Illinois Tollway Base Sheet Revisions

Section M		Base Sheet Drawings	
Drawing	Modification Summary	Effective: 2020-03-01	
Pole Assembly (ITS)-Series 1000			
M-ITS-1000	Elevation Views Pole Mounted ITS Element Assembly		
	Use 1 1/2" stainless conduits for power and fiber to ITS Enclosure instead of 2". Corrected the MVDS mounting height on elevation details Use 1 1/2" stainless conduit for ITS Disconnect switch		
M-ITS-1001	General Notes Pole Mounted ITS Assembly		
	Note added on placement of battery enclosure		
M-ITS-1002	ITS Standard Foundation		
	Note added to use 12 ft helix foundation for slopes over 1:6		
M-ITS-1003	ITS Concrete Service Pad		
	Shows option for back-to-back mounted ITS enclosures.		
M-ITS-1004	Cabinet Wiring Diagram - ITS Pole Mounted Enclosure (Solar Powered MVDS) (2 sheets)

M-ITS-1300
 SHEET 2 OF 2

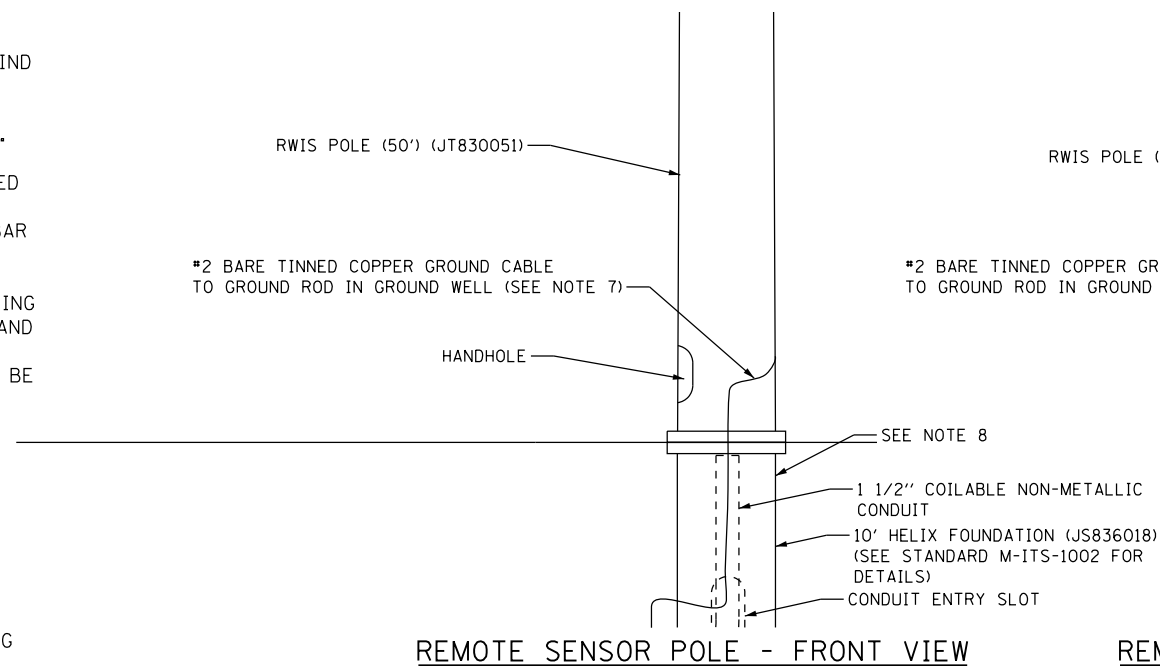
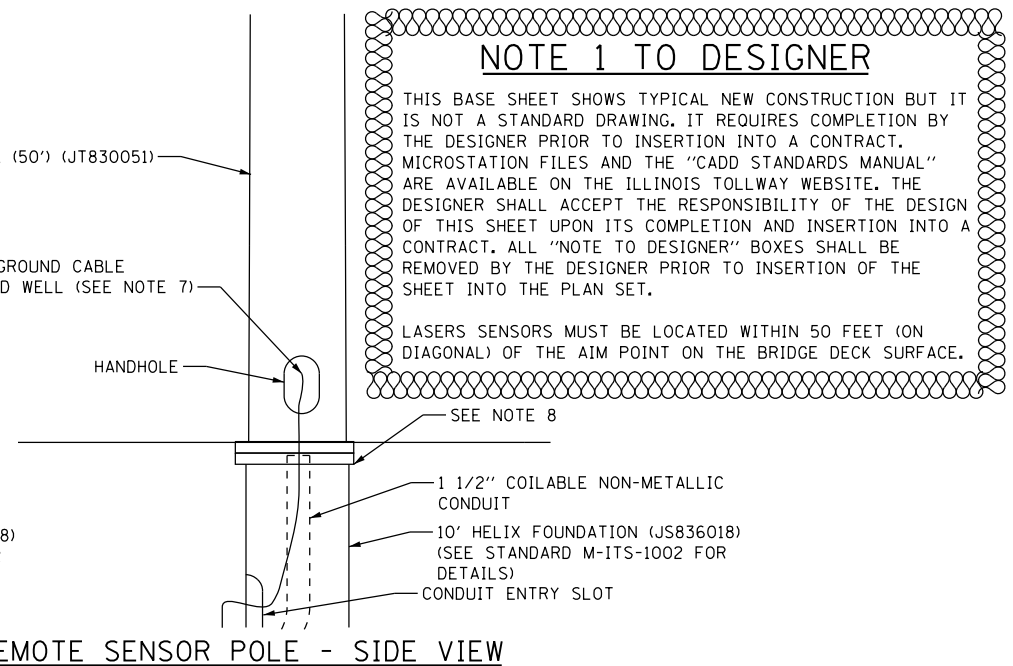
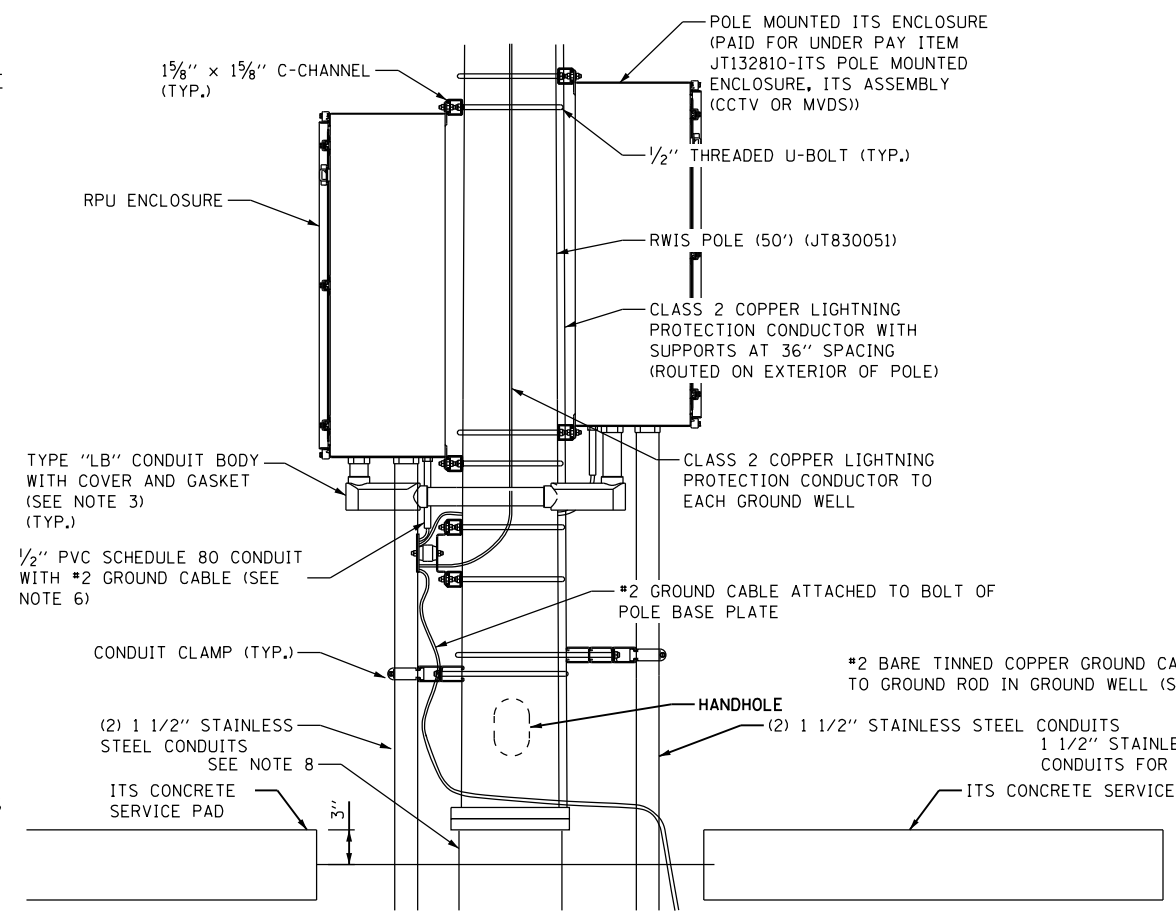
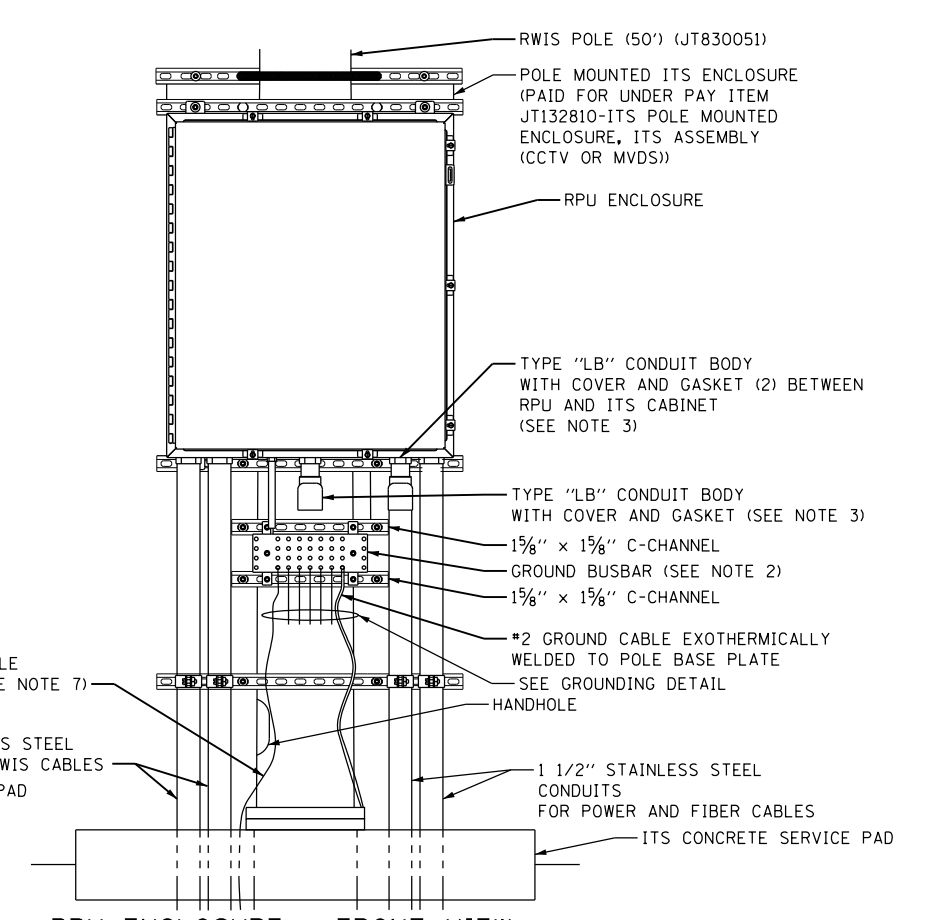
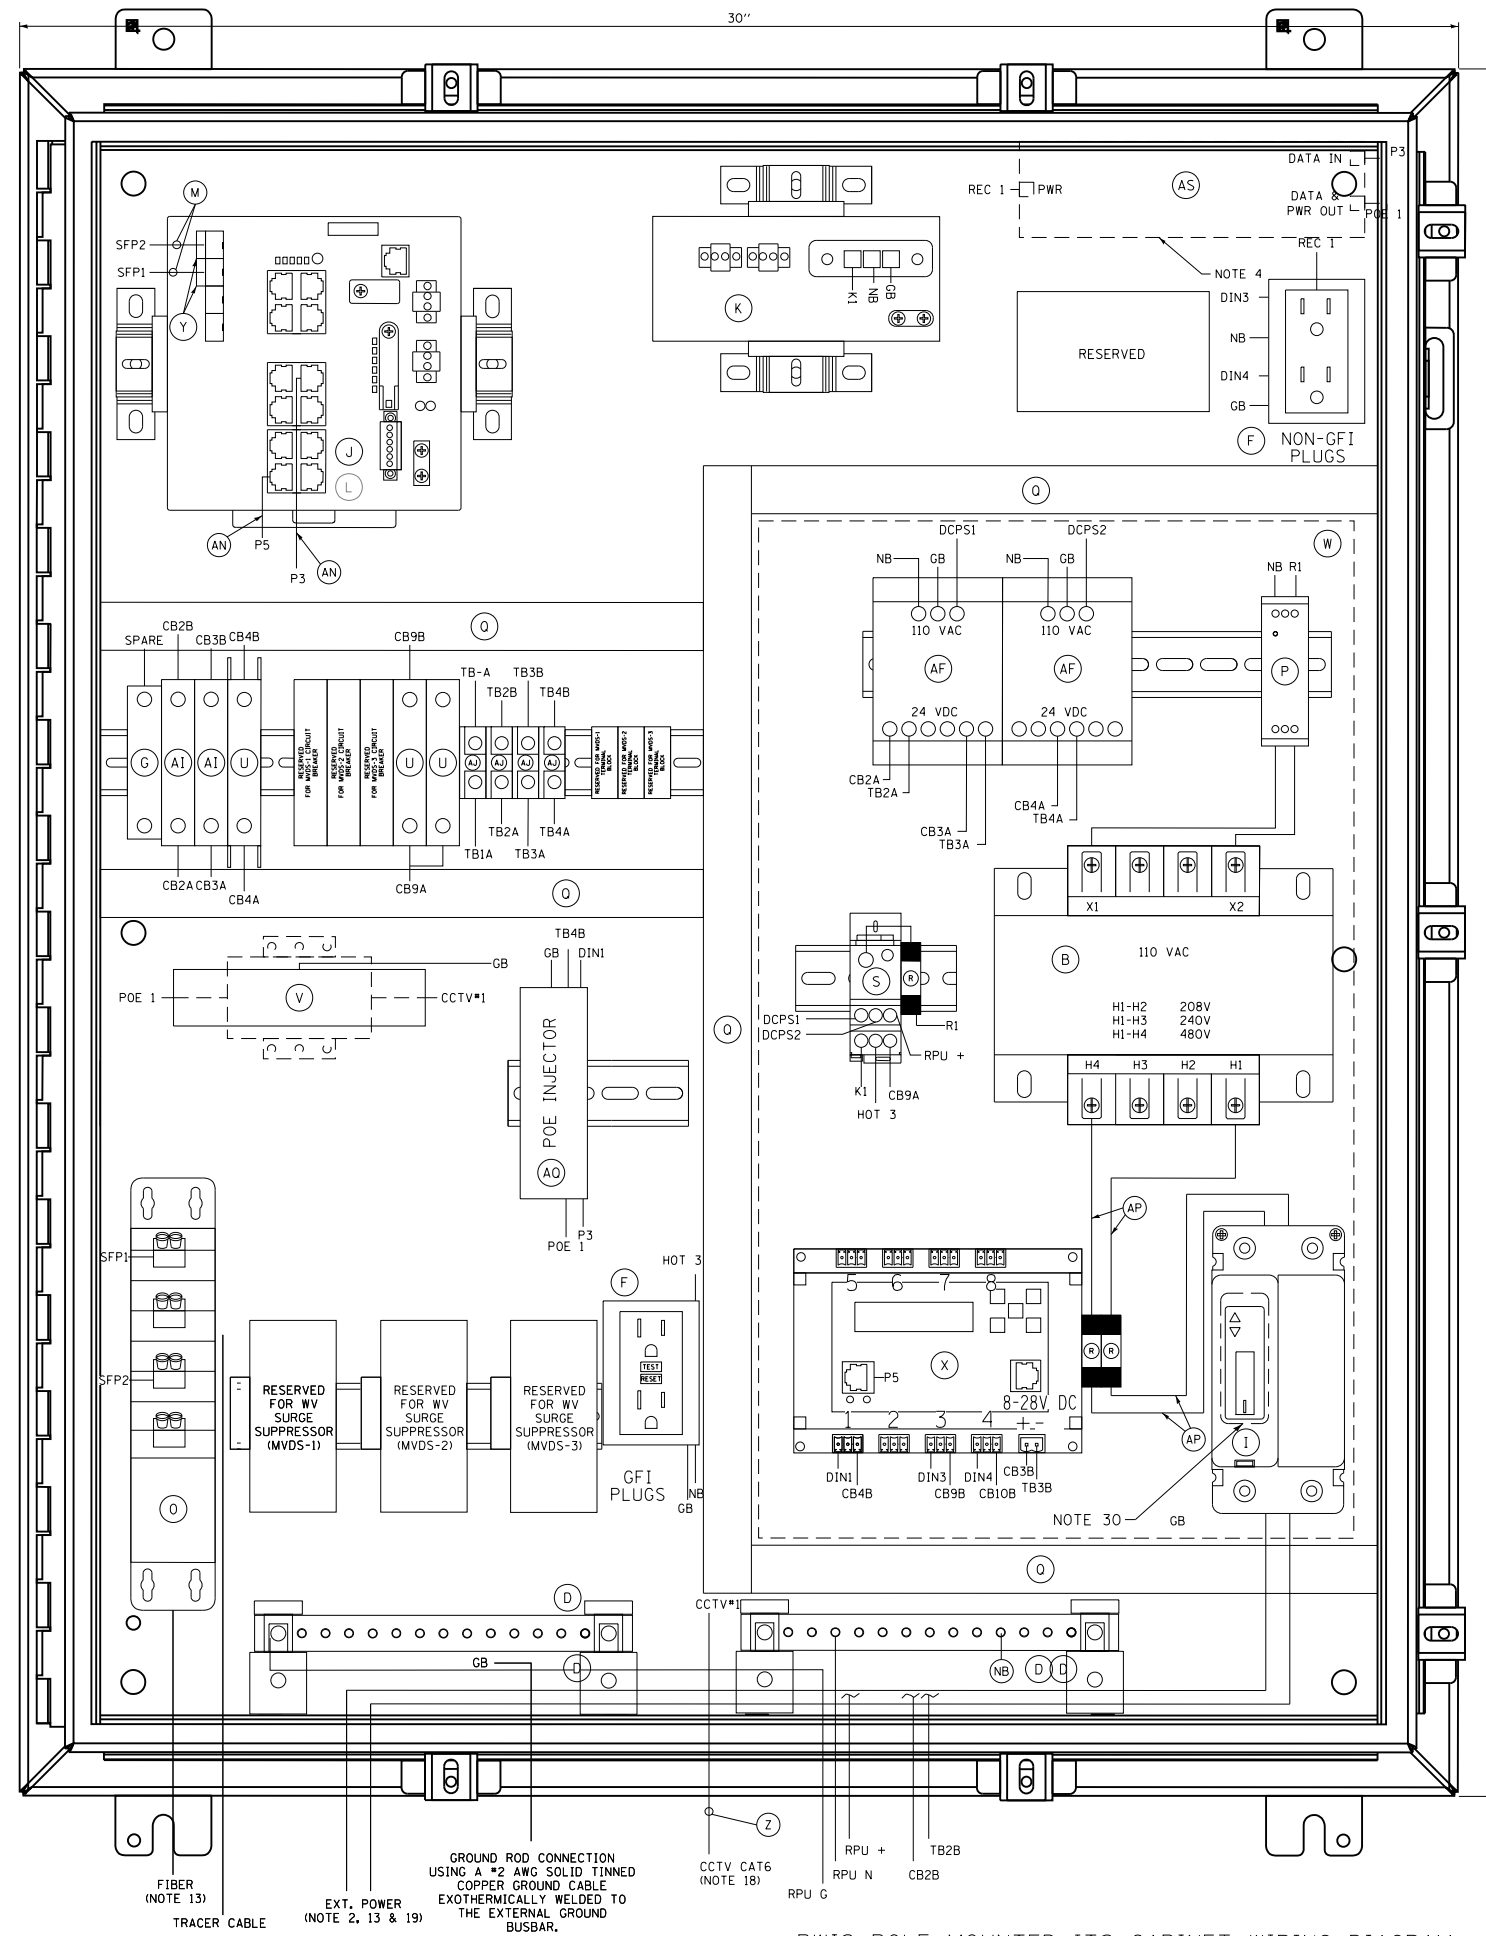
Sheet 1: Revised layout to better accommodate future expansion.		
Dynamic Message Sign (ITS)-Series 1100			
M-ITS-1100 to M-ITS-1108	DMS		
	(Typical) Revised Type 1 nomenclature to Walk-in (Typical) Revised Type 2 nomenclature to Front Access		
M-ITS-1101	DMS Type 1 Site Grounding Plan		
	Revised to show paved median structure		
M-ITS-1108	DMS Cabinet Wiring Diagram		
	Clarified wiring diagram Updated switch model		
Cabinet Wiring (ITS)-Series 1200			
M-ITS-1200 to M-ITS-1217	Cabinet Wiring Diagrams		
	New Cat6 surge suppressor Axis T8061 for Axis PoE camera and Ditek for Cohu PoE camera Revised layout for Cisco 4000 switch, power supply, Cohu PoE injectors Revised 1214-1216 plan to remove Cisco switch Added Level 3 Cisco license (L-IE4000-RTU=) Modified gator patch model number		
Roadway Weather Information System (ITS)-Series 1300			
M-ITS-1300	RWIS Pole, Sensor Mounting Detail		
	General note to have manufacturer to supervise installation and commissioning Revised to show option for co-located CCTV camera and ITS enclosure Clarified the mounting height measured from pavement surface Installed new ITS Enclosure back to back to the RPU enclosure Add ITS Disconnect switch within 50 feet from primary pole Show RWIS cabinet configuration for the 3 electrical services

M-ITS-1301
SHEET 1 OF 2

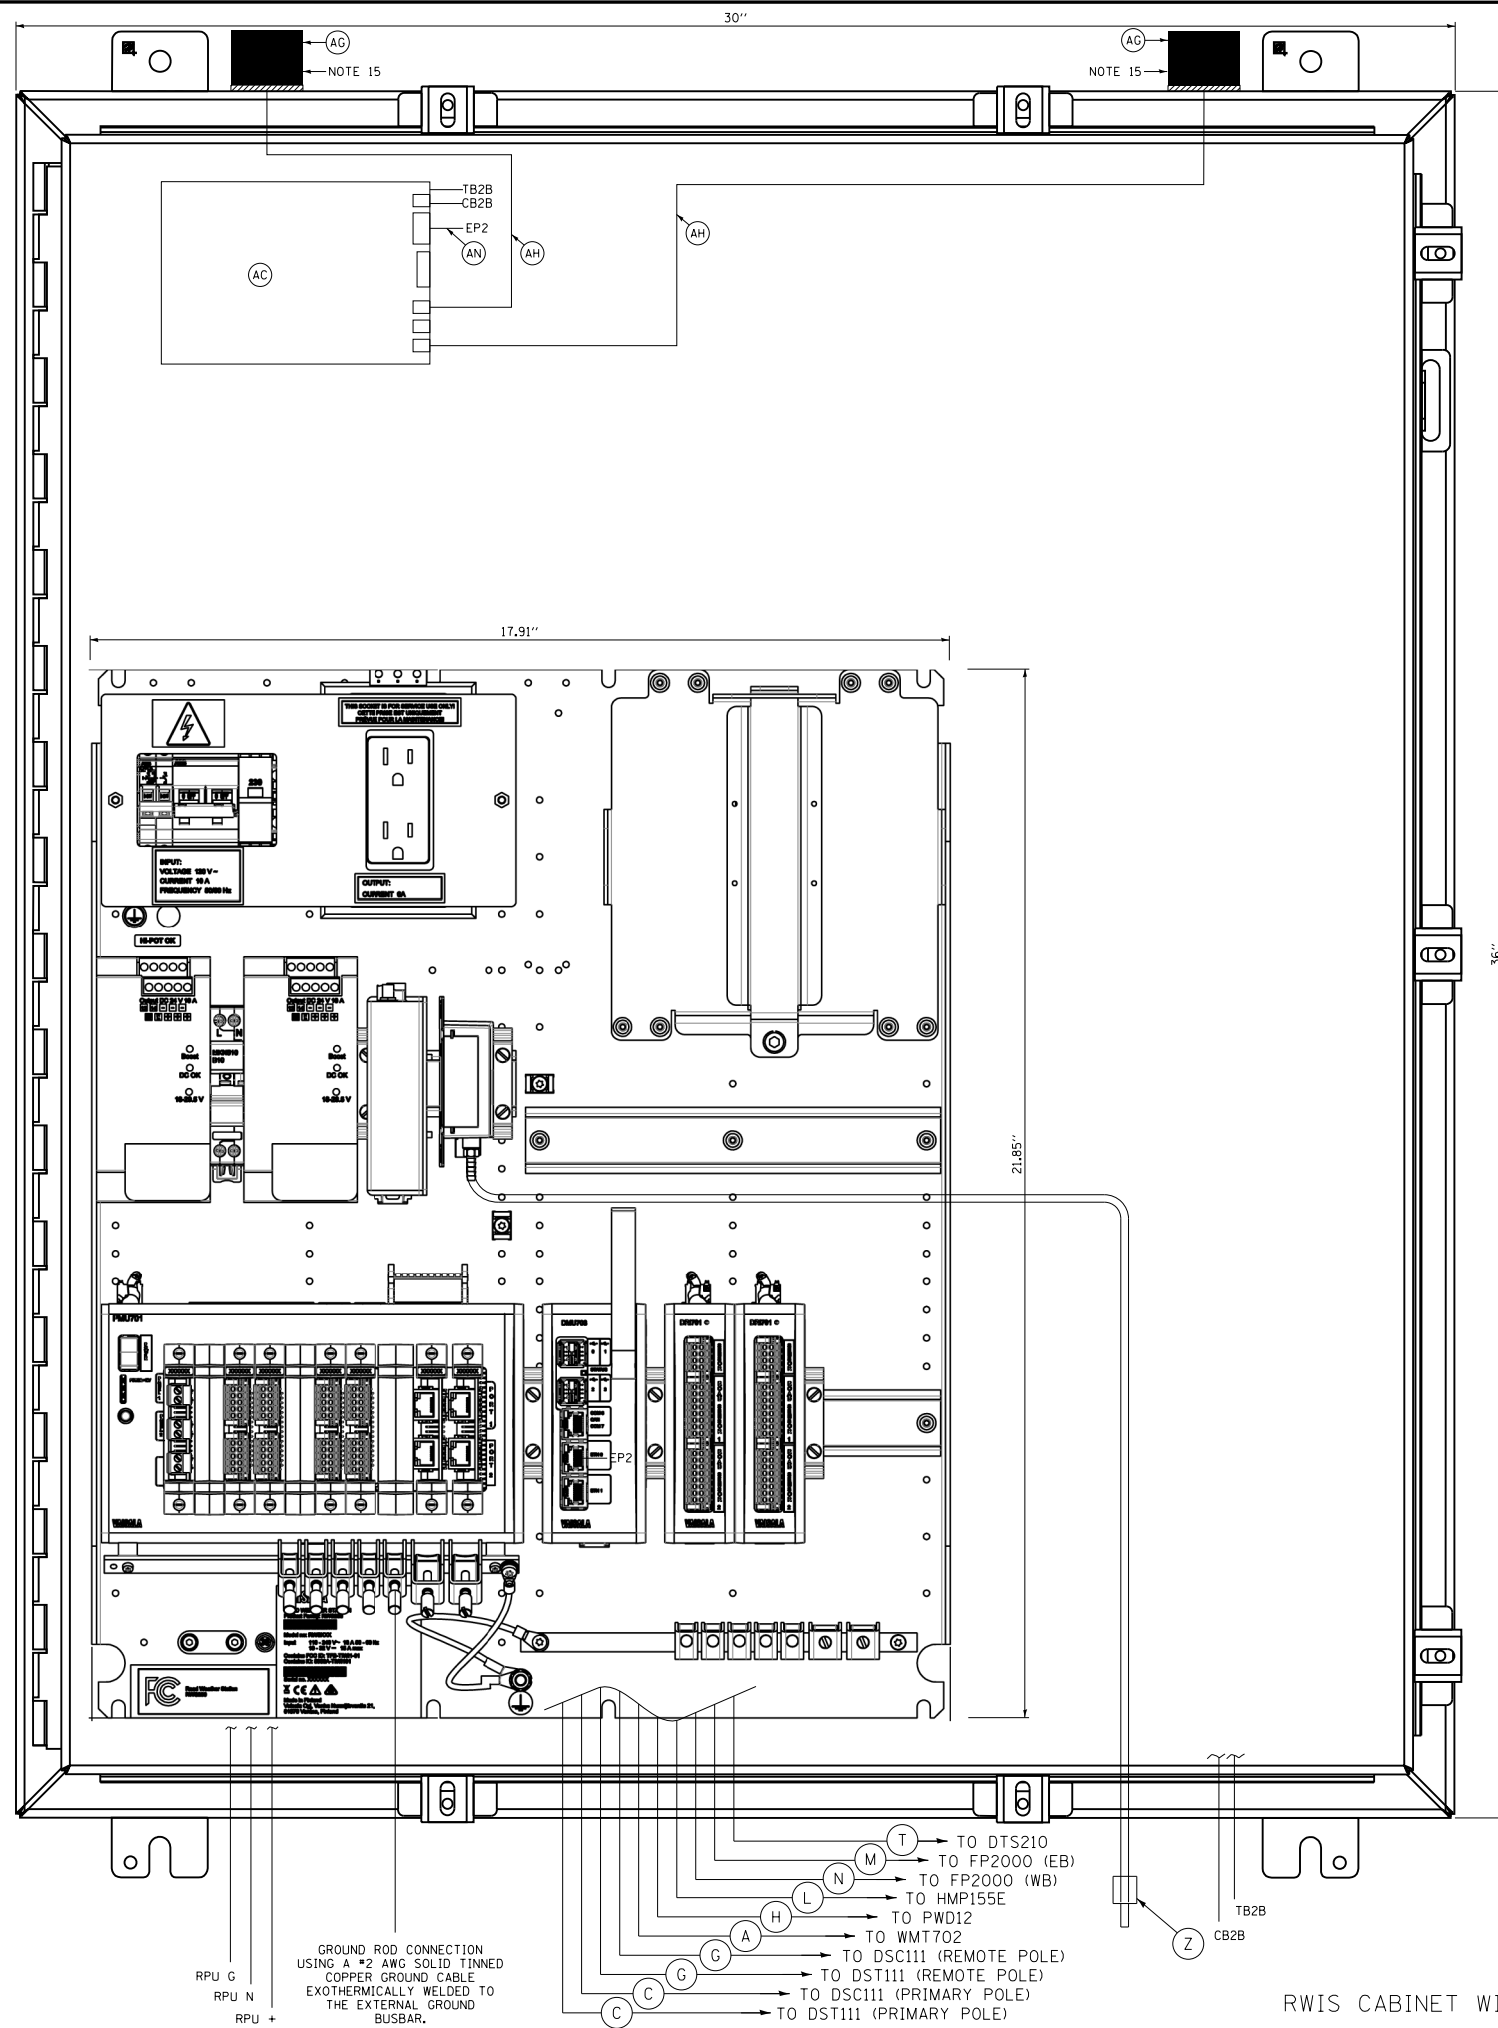
M-ITS-1301	RWIS Cabinet Wiring Diagram		
	Removed Cisco switch and gator patch from RPU enclosure		
M-ITS-1302	Typical RWIS Site Installation Plan		
	Proposed location of temperature sensors are site specific, final position to be determined by the Engineer in consultation with manufacturer. Correct sensor beam position to be in the wheel track for primary and secondary pole. Power cable from primary pole to secondary pole not to be spliced		
M-ITS-1303	RWIS Grounding Schematic		
	Corrections and additional detail to grounding diagram
